Re: Lebanon Gateway – Casey’s of Lebanon – Engineering Plans – 1415 West South Street, Lebanon, IN 46052

Kimley-Horn received comments on November 16, 2021 from the City of Lebanon Engineering Department for the proposed Casey’s of Lebanon development located at 1415 West South Street, Indiana 46052. The following are our responses and actions to the provided comments.

Review Comments

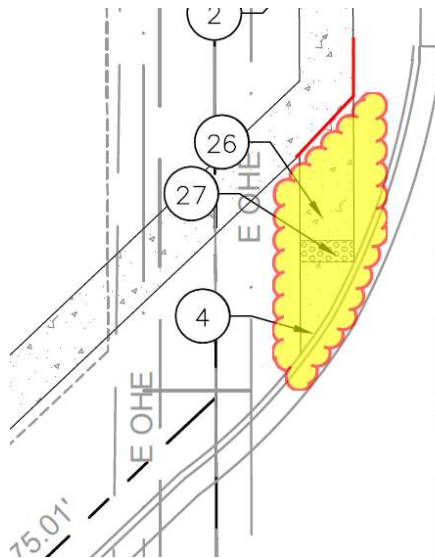
- d. **Extend 2’ combined curb and gutter all entire frontage of Ransdell Road, connecting to existing curb and gutter, provide for proper drainage.**

Response: Combined curb and gutter has been extended along the entire frontage of Ransdell Road.
